UNITED STATES PATENT AND TRADEMARK OFFICE

APPLICATION NO.	FILING DATE	FIRST NAMED INVENTOR	ATTORNEY DOCKET NO.	CONFIRMATION NO.
10/675,088	09/30/2003	Jung-Seon Park	CU-3336 VE	4762
26530 7590 09/06/2007 LADAS & PARRY LLP 224 SOUTH MICHIGAN AVENUE SUITE 1600 CHICAGO, IL 60604			EXAMINER KARLS, SHAY LYNN	
			ART UNIT 1744	PAPER NUMBER
			MAIL DATE 09/06/2007	DELIVERY MODE PAPER

DETAILED ACTION***Drawings***

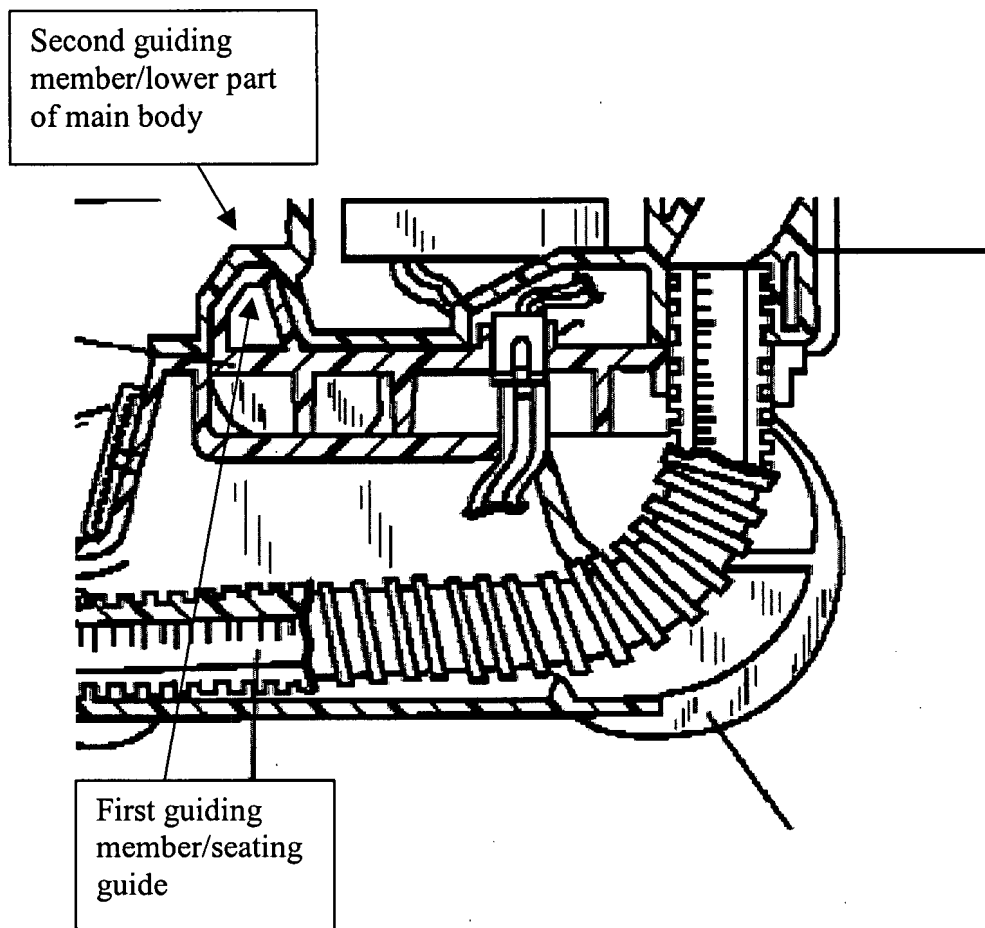
connecting portion (200) that protrudes upwardly from the connecting portion (claim 1). There is a second guiding member corresponding to the first guiding member on the lower part of the main body (see figure below) (claim 13). The at least one guiding member is shaped in to a convex protrusion (cross section shows a convex shape in figure below) and the second guiding member is shaped in to a concave groove (cross section shows a concave groove in figure below) (claim 13). The main body has a corresponding receptacle into which the second guiding member is received (portion 44 of figure 7 receives the concave second guiding member). Weaver also teaches a nozzle having a connecting portion that include a shaft member (230, 232) extending downward for pivotally connecting the shaft member with the nozzle (claim 18). The shaft is received in recesses (264, 266) for pivoting. Weaver's vacuum also comprises a first fixing portion (250) formed at the upper part of the nozzle (16) and a second fixing portion (lower surface of 200) formed at the lower part of the frame assembly (18). The first fixing portion corresponds to the second fixing portion to provide a connection between the connecting portion and the frame assembly (claims 20 and 21).

It would have been obvious to one of ordinary skill in the art at the time the invention was made to use the pivoting nozzle assembly as taught by Weaver on the frame assembly as taught by Downey and modify the lower surface of the main body so that the communicating member and power connector of Downey match up with the communication hole and power port of Weaver, as well as modify the shape of the lower surface of the main body so the guide members fit together. Modifying the shape of elements are considered to be within the level or ordinary skill in the art. MPEP 2144. Since Downey is silent as to the type of nozzle used with

**Fig. 1**

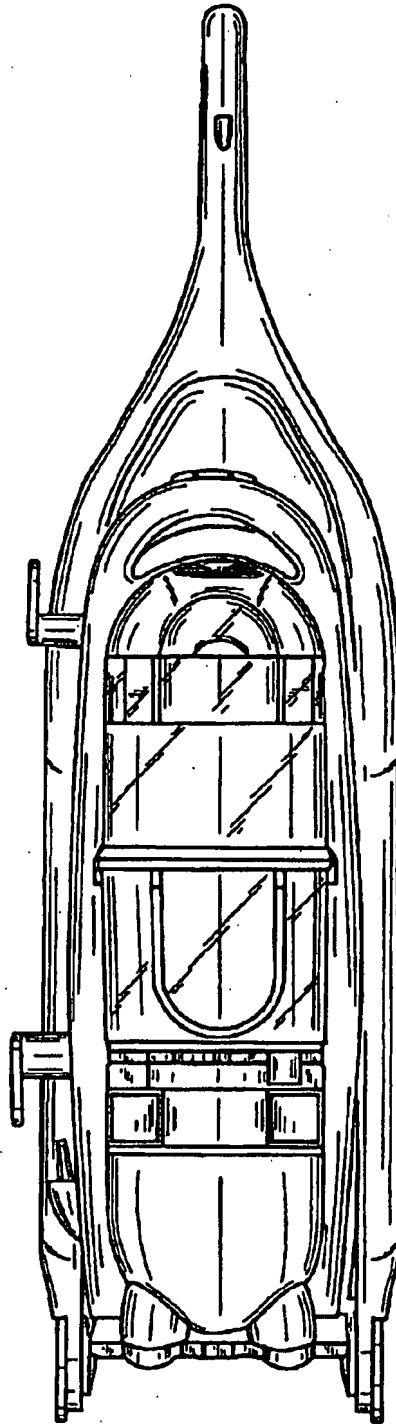
Downey teaches a vacuum cleaning handle portion for drawing in air having dust and dirt. See attached figures for labeled elements. There is a main body including a body frame, a dust collector connected to the body frame and a drive motor (figure 1). There is a frame assembly including a frame body (figure 1) and a connecting portion (figure 1, 5 and 7) formed with a lower part of the frame body. The frame body further comprises a front casing facing forward with respect to the vacuum cleaner and a rear casing coupled to the front casing (figure 5). The frame body is shaped to correspond to an outer circumference of the main body (figure 1).

With regards to claim 5, the frame body further comprises a wheel (figure 1) connected to the lower part of the frame assembly.

With regards to claim 6, the main body of the vacuum is connected to the dust collector (figure 1) and further comprises a dust receptacle (inside of dust collector) removably connected to the body frame for collecting dust and dirt. There is a button formed at an upper part of the body frame (figure 1).

With regards to claim 7, the frame assembly further comprises a frame handle (figure 1) disposed at an upper part thereof, and there is a handle groove (figure 1) disposed at a position corresponding to the button of the main body of the vacuum cleaner.

With regards to claim 19, there is an on/off switch (figure 1) disposed at a front part of the main body.

Fig. 3

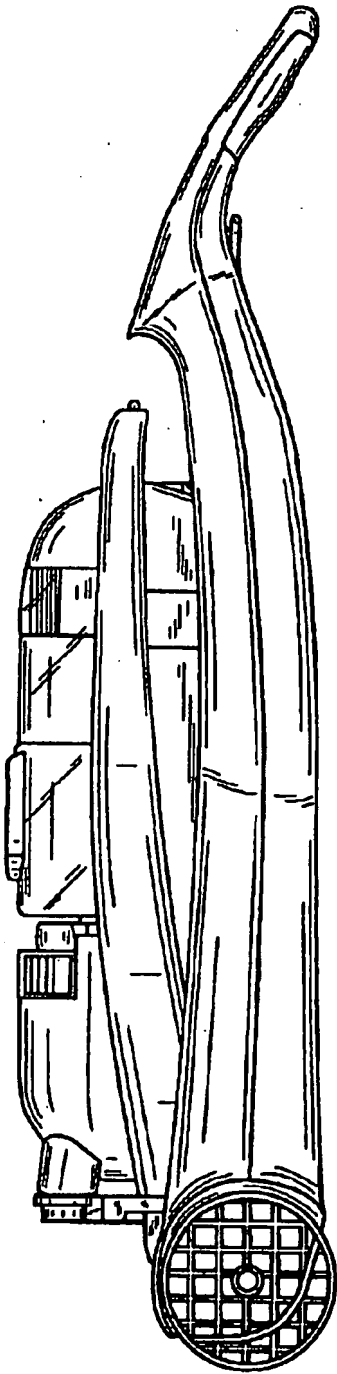
With regards to claim 4, the frame assembly further comprises a connecting guide for removable connecting accessories to the vacuum cleaner (figure 3).

Fig. 7

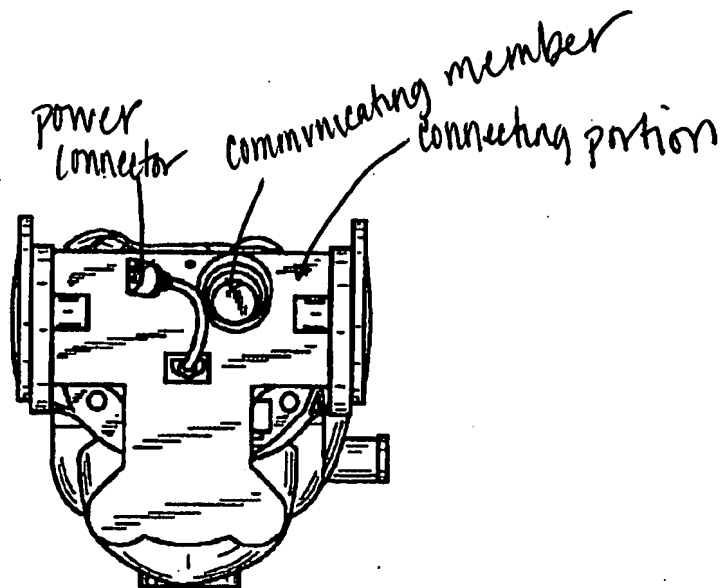
With regards to claim 10, the connecting portion comprises a communicating member (figure 7) formed at the main body of the vacuum.

With regards to claim 11, there is a power connector disposed on the lower part of the main body (figure 7).
